R20TS0494EJ0100

RX Family SCI Module Firmware Integration Technology, RX Driver Package

Outline

➤ CPU processing that results in correct transmit data

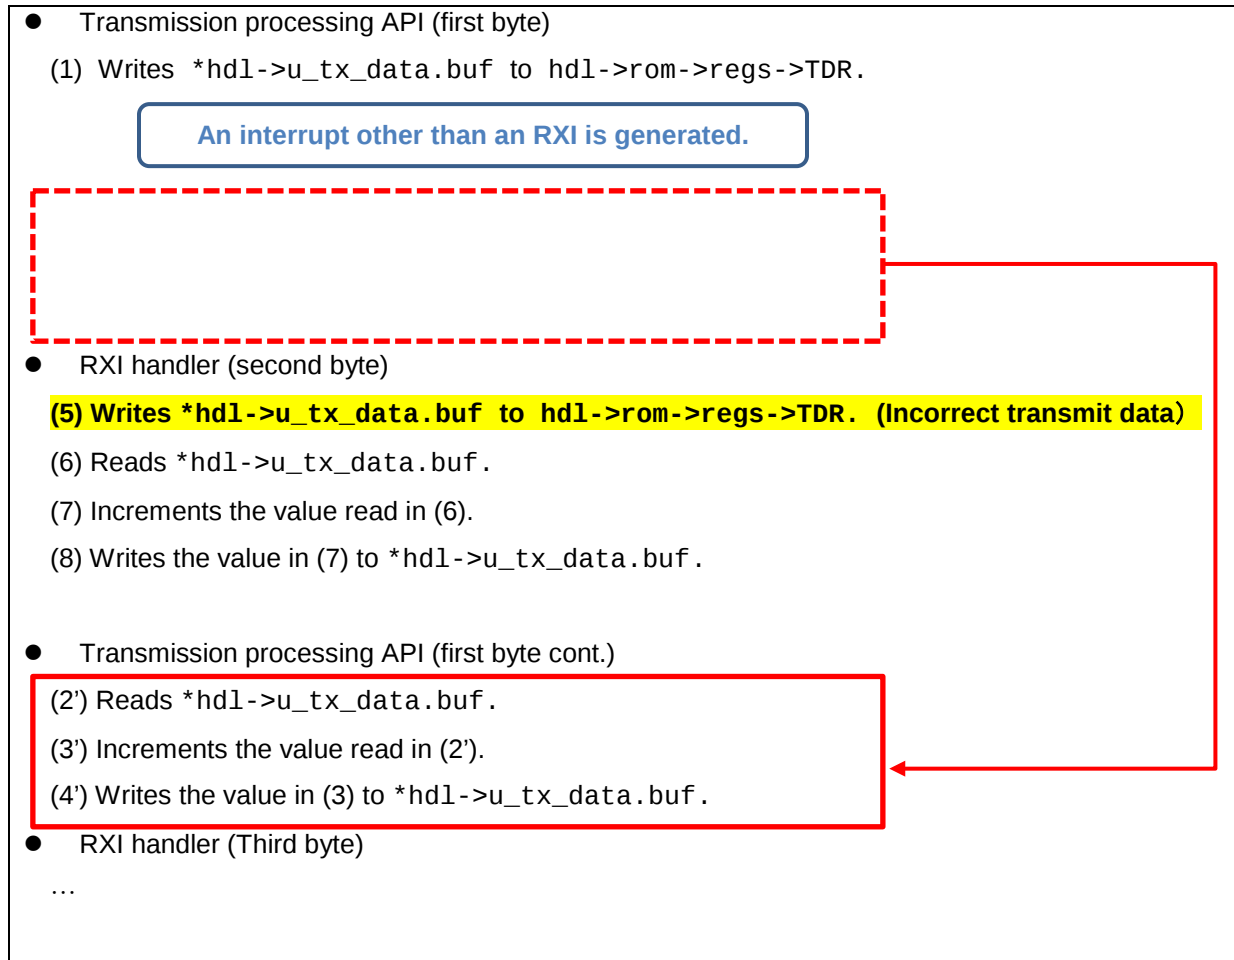
The processes enclosed in a red frame show the steps involved in incrementation of the transmit data buffer counter.

After data is written to the TDR, both processes are performed before the next data is sent (RXI handler).

- Transmission processing API (first byte)
 - (1) Writes *hdl->u_tx_data.buf to hdl->rom->regs->TDR.
 - (2) Reads *hdl->u_tx_data.buf.
 - (3) Increments the value read in (2).
 - (4) Writes the value in (3) to *hdl->u_tx_data.buf.
- RXI handler (second byte)
 - (5) Writes *hdl->u_tx_data.buf to hdl->rom->regs->TDR.
 - (6) Reads *hdl->u_tx_data.buf.
 - (7) Increments the value read in (6).
 - (8) Writes the value in (7) to *hdl->u_tx_data.buf.
- RXI handler (third byte)
- ...

When an interrupt other than an RXI is generated between (1) and (2) in "CPU processing that results in correct transmit data"

If transmission processing (1) is completed while processing an interrupt other than an RXI, RXI handler processing (second byte) is performed without incrementing the transmit buffer counter in (2) to (4).

For this reason, a wrong value is written to the TDR, resulting in incorrect transmit data.

- (1) Disable interrupts before the “SCI_TDR” processing.

```
R_BSP_InterruptsDisable(); /* Disable interrupts */
SCI_TDR(*hdl->u_tx_data.buf++);
R_BSP_InterruptsEable(); /* Enable interrupts */
```

- (2) Increment “*hdl->u_tx_data.buf” before the “SCI_TDR” processing.

Replace the line in “Before correction” with the following four lines in red.

```
uint8_t *buf_copy;
buf_copy = *hdl->u_tx_data.buf;
*hdl->u_tx_data.buf++;
SCI_TDR(buf_copy);
```
